PCN N° 2023-141-A

Harmonization of 60mm Standard Module Housing

Subject Change of Housing concept for 60mm Modules and Chip Harmonization

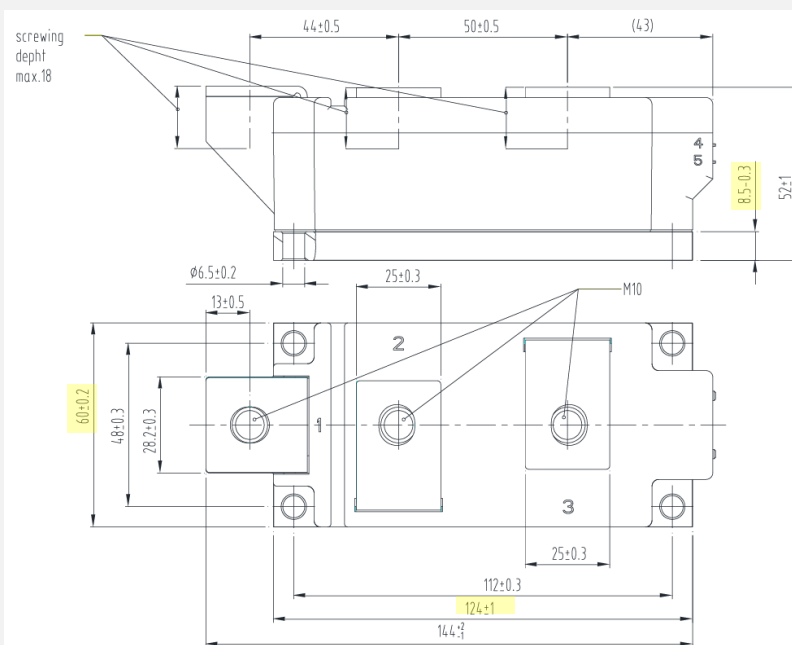
Description Old

- Encapsulation: hard resin
- Baseplate thickness: 8.5mm
- Baseplate material: Copper
- Outer dimension of module footprint: L=124mm; W=60mm

- New

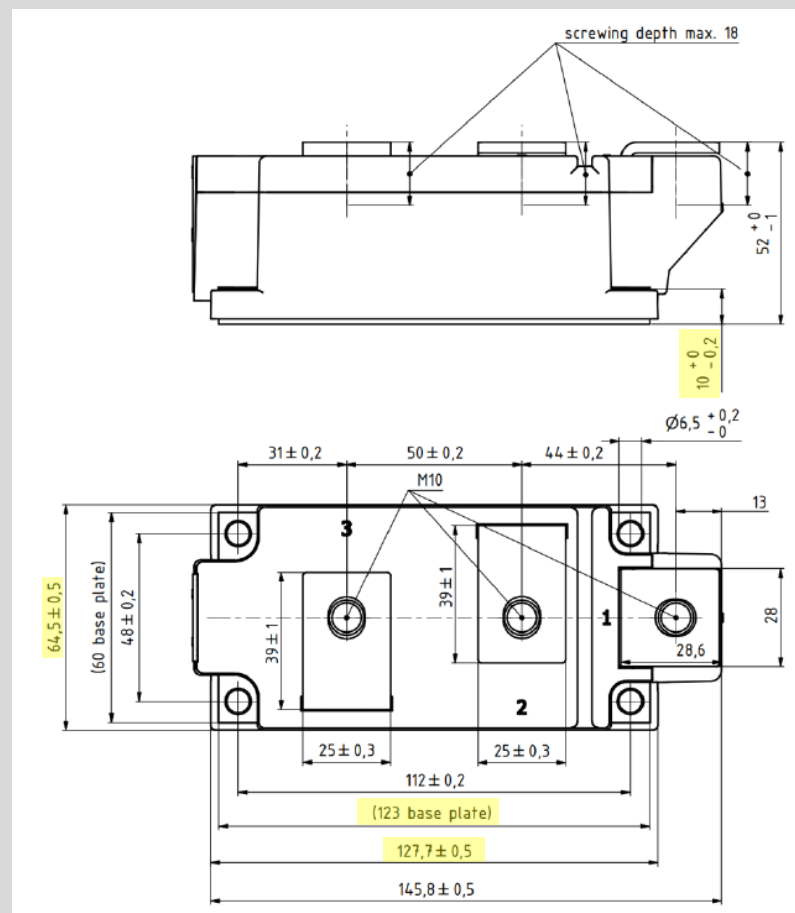
Change of external dimensions of module
No change in electrical and thermal data

- Encapsulation: soft gel
- Baseplate thickness: 10mm
- Baseplate material: Aluminum
- Outer dimension of module footprint: L=127,7mm; W=64,5mm
